OVERVIEW

VOLUNTEER PARK DRIVE PLAZA PAVING

PLAZA DEMO PLAN

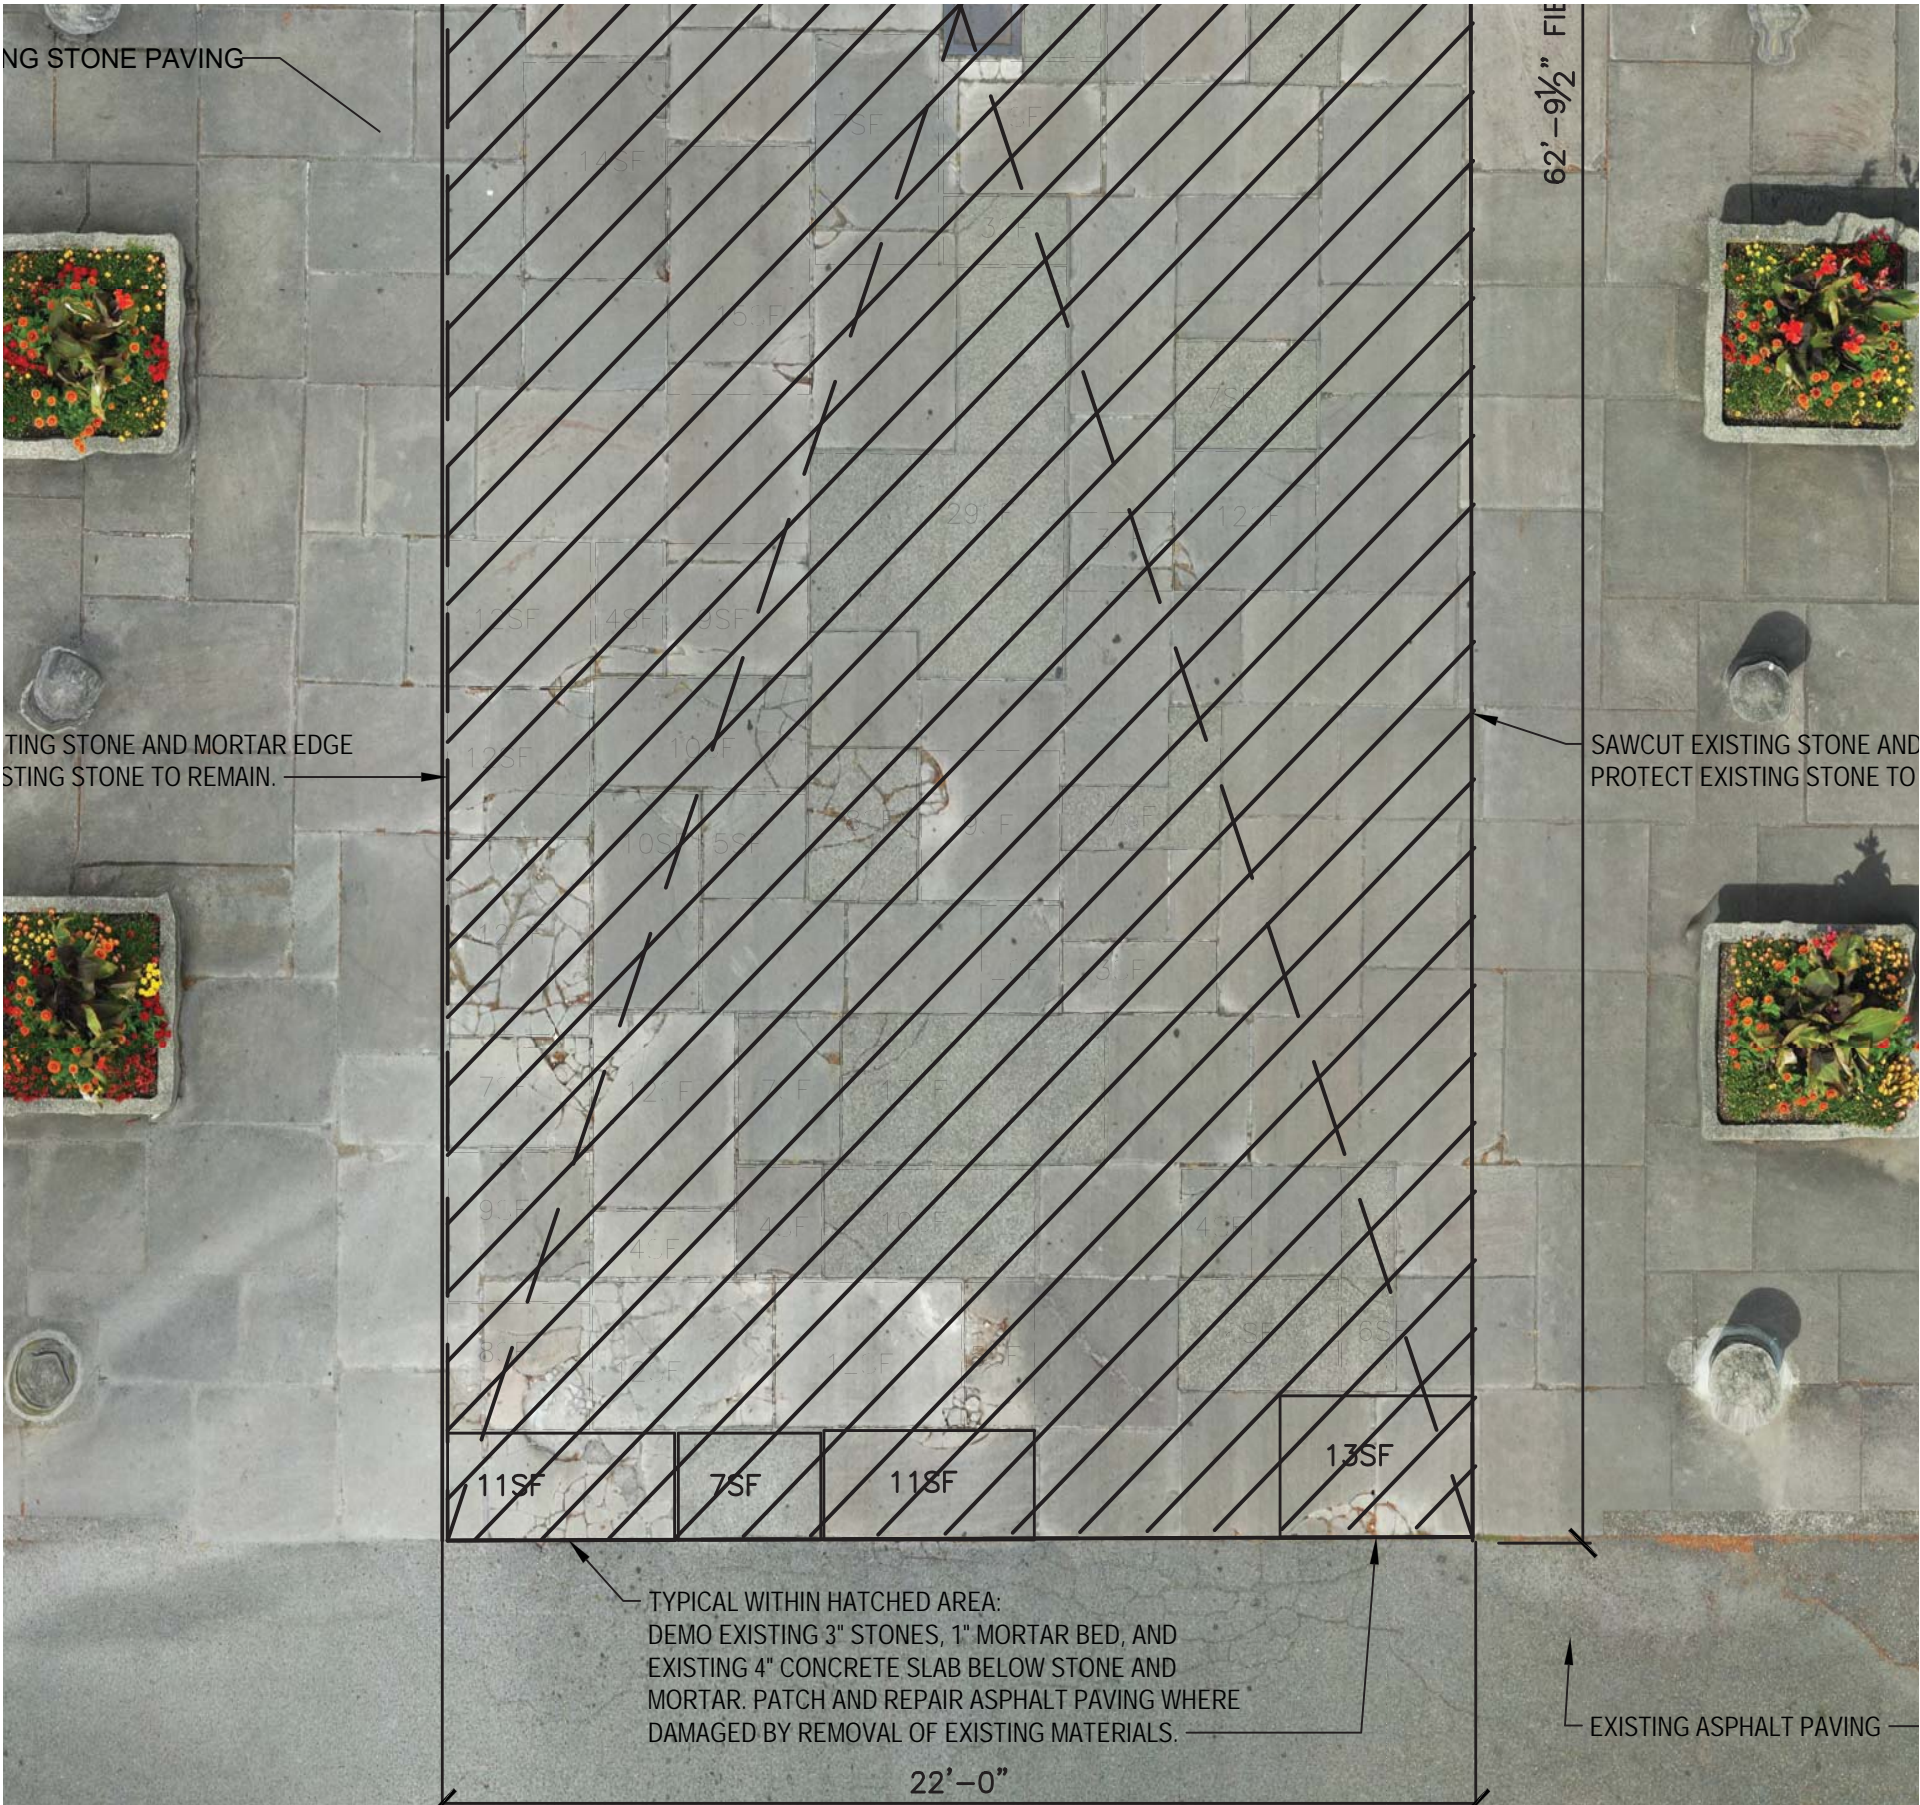
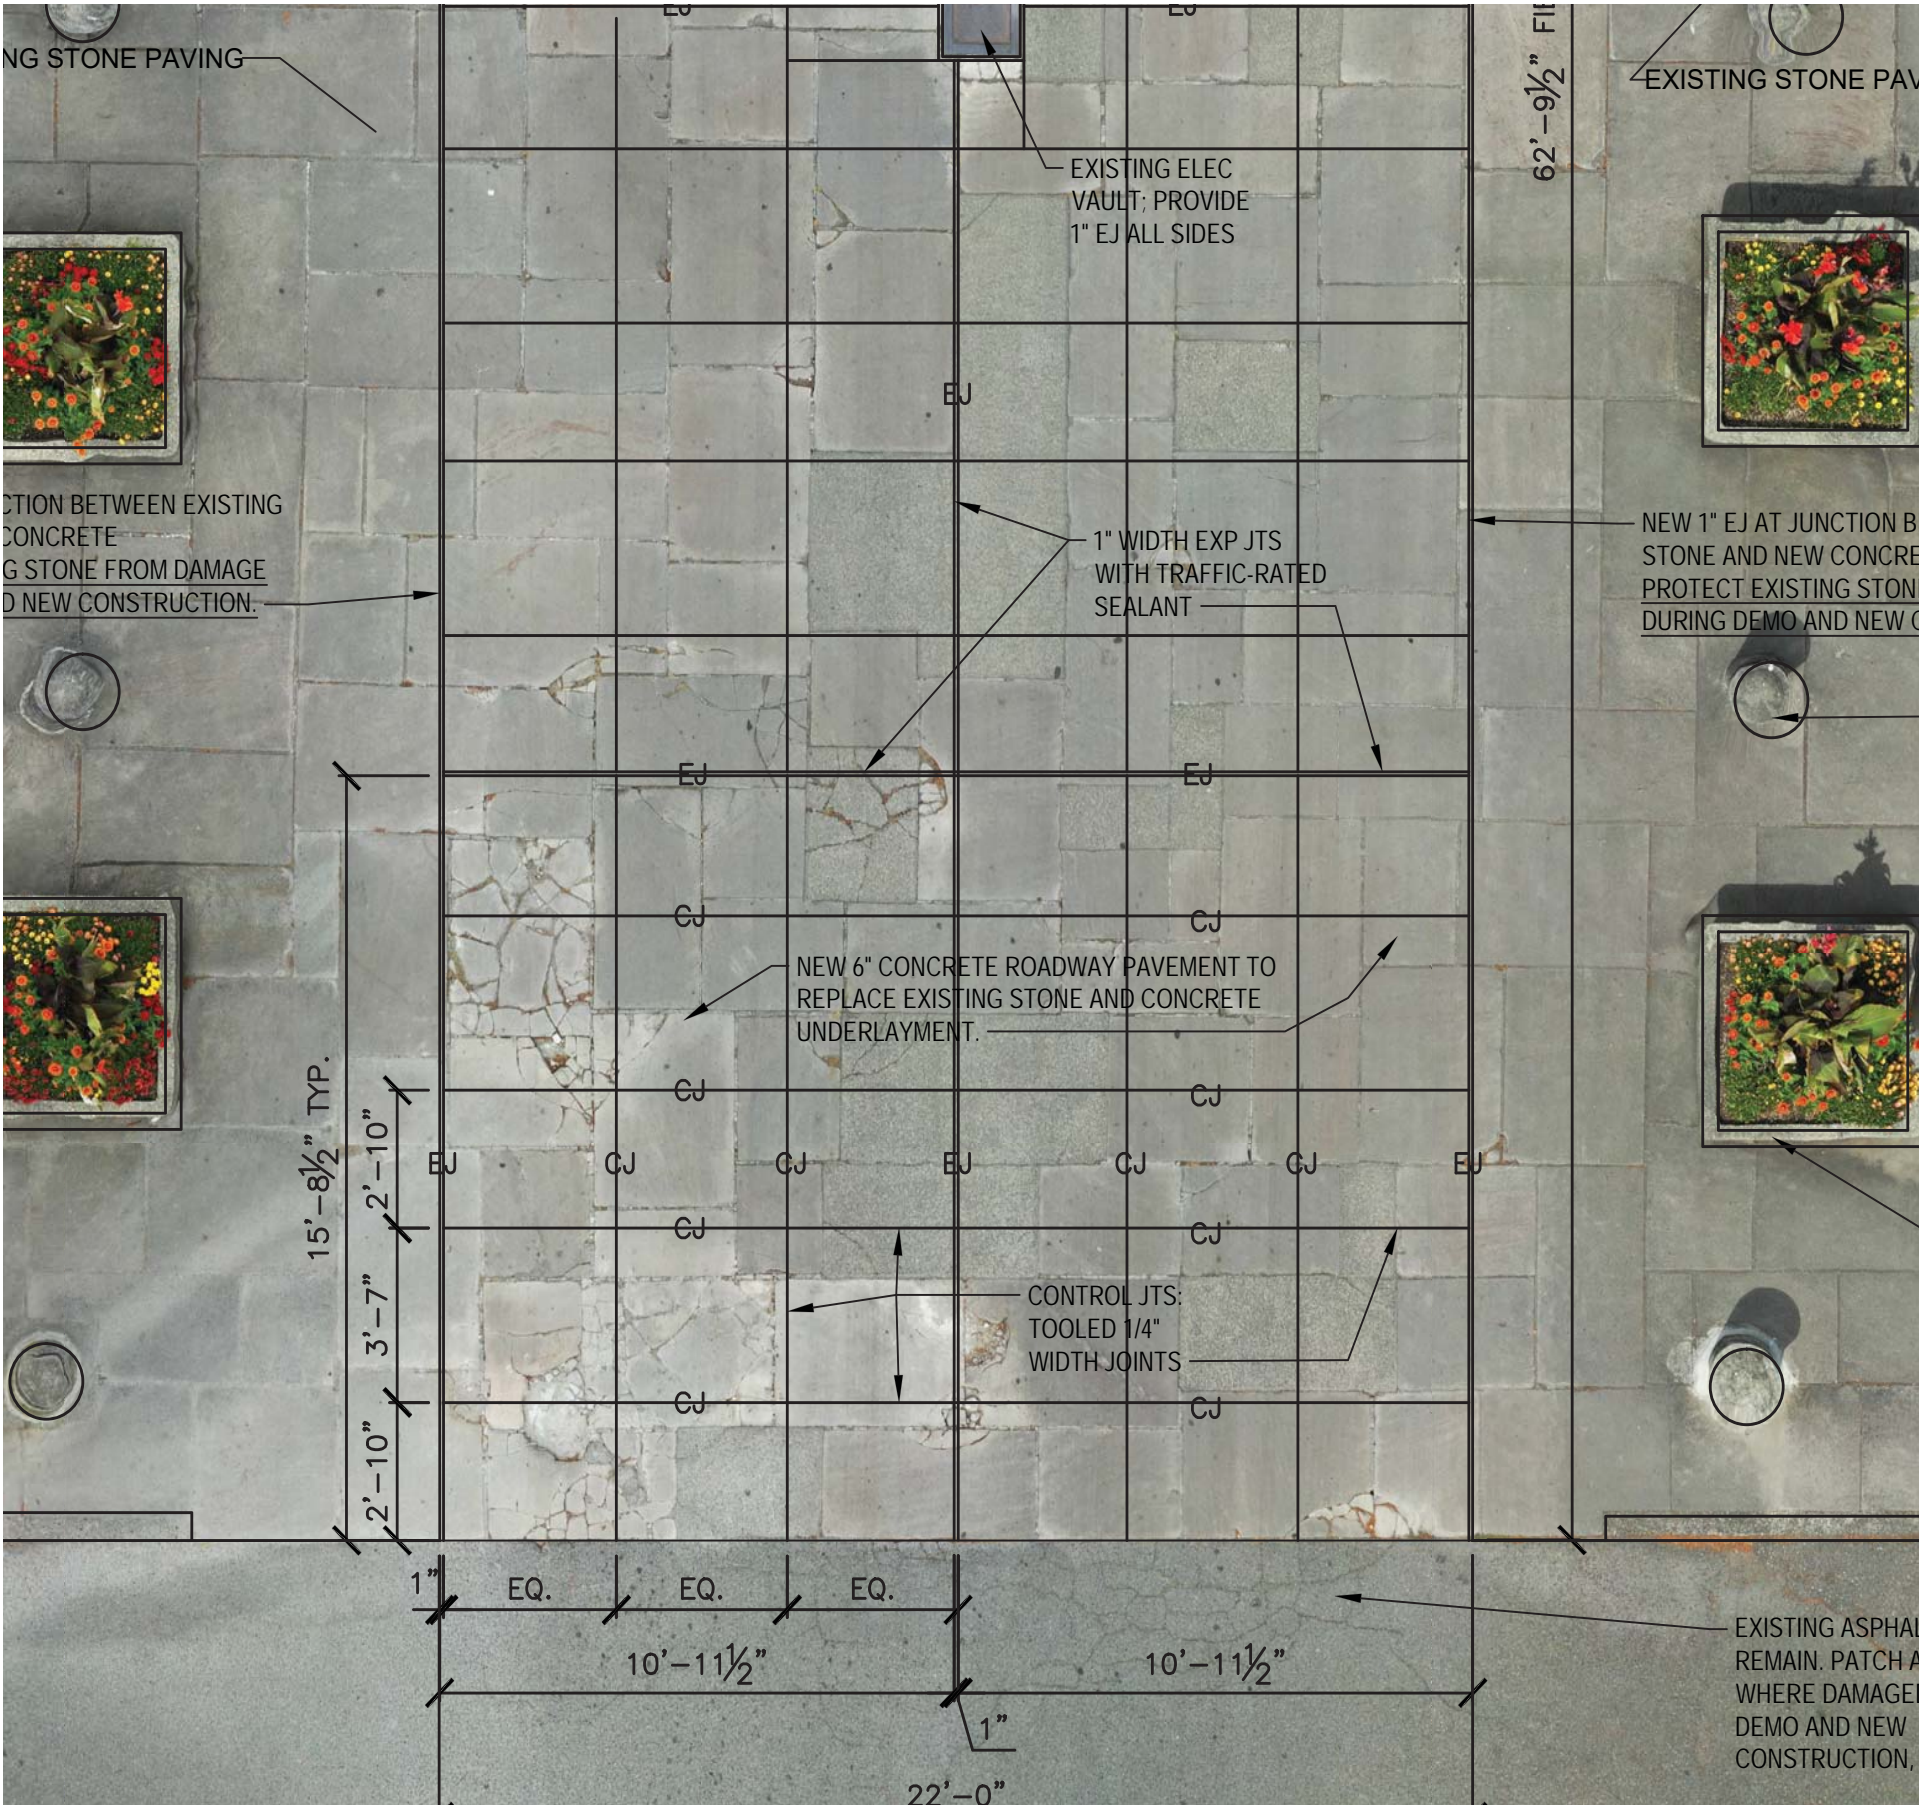
Jennifer Ott, Chair of Volunteer Park Trust, reviewed the proposed changes and indicated support provided that the replacement paving was designed to blend well with the color and scale of the stone paving. She believes that extending the plaza across VP Drive was the most significant contribution by Haag to the Park, but the stone within the vehicle areas is not sustainable, and replacing the stone with concrete can maintain Haag's intent while addressing the poor performance of the stone in the traffic areas.

The Friends of Seattle Olmsted Parks were still assembling the review group to provide comments at the time of printing this presentation, and we anticipate being able to share their feedback in the ARC meeting. Preliminary review comments by a key member, Andy Mitton, was similar to Jennifer Ott's, feedback regarding support for the overall approach. He highlighted the importance of protecting the adjacent stone during the demolition and new construction.
